Groundwater Application Review Summary Form

Application # G- 19070

**SUBJECT: Scenic Waterway Interference & General/Local Surface Water
Evaluation for Deschutes Ground Water Study Area**

TO: Water Rights Section Date 6/30/2023
 FROM: Groundwater Section Joe Kemper
 Reviewer's Name
 SUBJECT: Application G- 19070 Supersedes review of 12/6/2021
 Date of Review(s)

Water-Level Measurements in Nearby Wells – red circle highlights water level measurement from proposed POA (DESC0052024); boxes show water level well groups above/within and below the Sisters Fault Zone (SFZ).

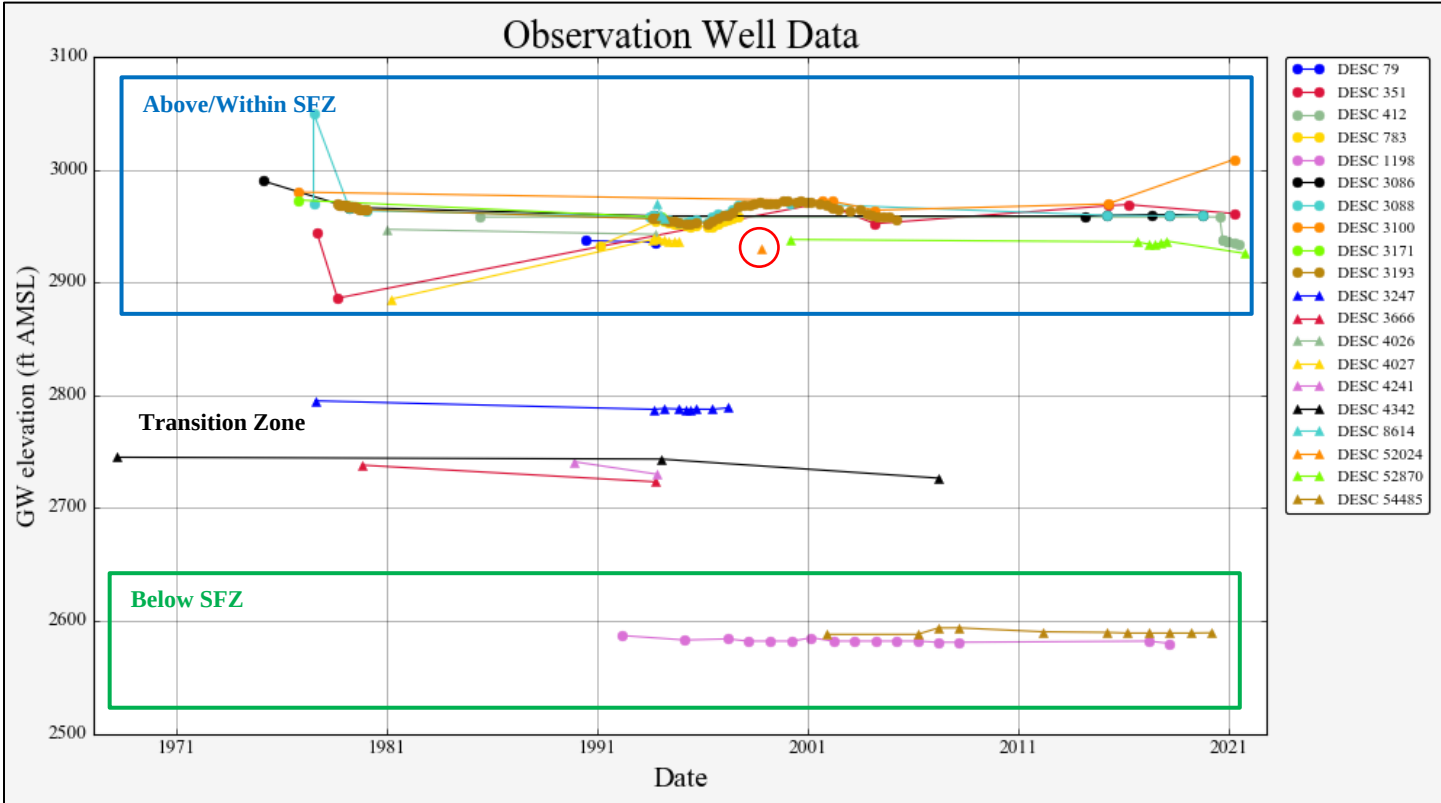
- B3. **Groundwater availability remarks:** The applicant's proposed POA would be producing from an area of the Deschutes basin that is within the Sisters Fault Zone, which is nearly 10 miles wide in this area. Water levels to the northeast of this zone generally show long-term declines while water levels to the west of this zone show water level trends resembling short- and mid-term climate cycles (annual to decadal). Water levels within this zone represent a transition. The single water level for the proposed POA is similar in elevation to water levels from wells that show climate variation and not long-term declines, so the proposed POA is assumed to be following a similar trend (but there is not sufficient water level data to definitively conclude this). Given that water level data in nearby wells do not show long-term declines, and that the applicant's POA is likely following a similar trend, there is not a preponderance of evidence that the proposed use would not be within the capacity of the resource or **targets an aquifer that is found to be over appropriated**. Despite this finding, however, groundwater flow from the area of the proposed POA is toward the northeast and into the zones of long-term declines and any new use up-gradient to this zone does have the potential to reduce flow to that zone.

- i. ☒ The permit should contain condition #(s) 7N (Annual SWL); Medium Water-Use Reporting;
 - ii. ☐ The permit should be conditioned as indicated in item 2 below.
